PG&E Vierra Reinforcement Project – Application No. 18-06-004
Data Request Set No. 1 – Initial Responses
October 29, 2018

Vierra Data Request No. 1 includes the first round of data requests for the following technical areas:

Single Circuit TSP

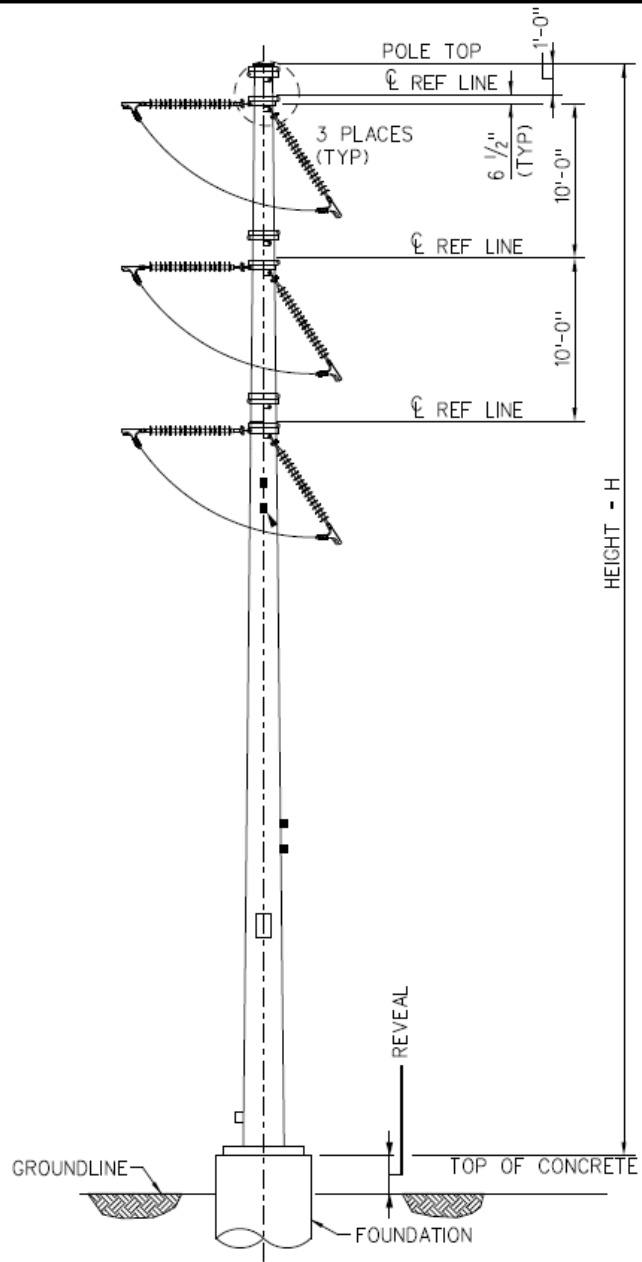
PD-5 PEA Section 2.5 states that the proposed project would require single-circuit towers/poles on the west side of the Vierra Substation. Please provide single-circuit tower/pole structure configurations and measurements.

PG&E Response: Single-circuit pole structure configuration and measurements figures are attached at the end of this document.
